Access Compliance Report

Public Rights-of-Way

Intersection ID: 10637	Main Street: COKER_AV	Cross Street: MATHIS_DR	Location: E
ADA ID: 21395B16DBCD	Ramp Type: Directional1	Initial Pass/Fail: Fail	Overall Compliance: No
Codes/Mitigation Info/Possible Solution		Field Measurements/Component Compliance	
Severity Score: 1.25

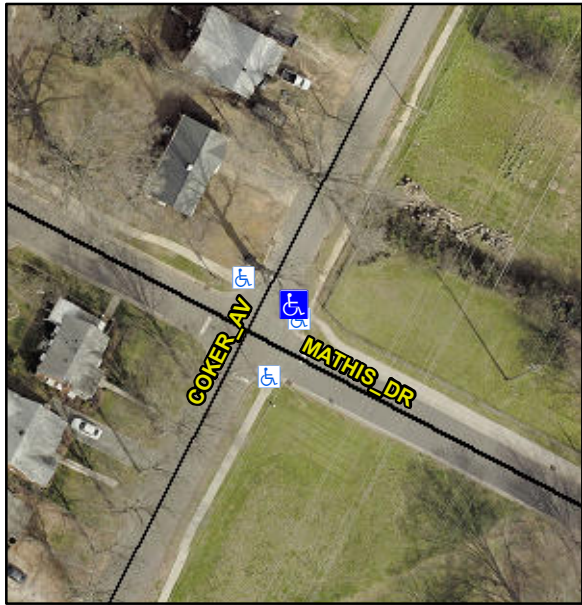
Possible Solutions:

Remove & Replace Entire Ramp.

R304.5.3

Compliance	Description	Data	Compliance	Description	Data
N/A	Ramp Length (in)	48.0	N/A	Grade Break?	N/A
Yes	Ramp Width (in)	58.0	N/A	Grade Break Slope (%)	0.0
Yes	Ramp Slope (%)	7.9	N/A	Grade Break XSlope (%)	0.0
No	Ramp XSlope (%)	4.3			
N/A	Flare Type LT	N/A	N/A	Flare Type RT	N/A
N/A	Flare Slope LT (%)	N/A	N/A	Flare Slope RT (%)	0.0
N/A	Flare Traversable LT?	N/A	N/A	Flare Traversable RT?	N/A
N/A	Landing Length (in)	0.0	N/A	DWS Provided?	N/A
N/A	Landing Width (in)	0.0	N/A	DWS Contrast?	N/A
N/A	Landing Slope (%)	0.0	N/A	DWS Length (in)	N/A
N/A	Landing X Slope (%)	0.0	N/A	DWS Full Width?	N/A
N/A	Landing Curb? (Y/N)	N/A	N/A	DWS Offset LT (in)	N/A
N/A	Shared Landing?	N/A	N/A	DWS Offset RT (in)	N/A
N/A	Gutter Ponding?	0.0	N/A	Gutter Slope (%)	N/A
N/A	Gutter Lip Ht (in)	0.5	N/A	Gutter X Slope (%)	N/A
N/A	Painted X Walk1?	No		Road Slope (%)	1.2
	X Walk 1 Direction	To NW		Road X Slope (%)	2.5
	X Walk 1 Width (in)	N/A		Clear Space?	N/A
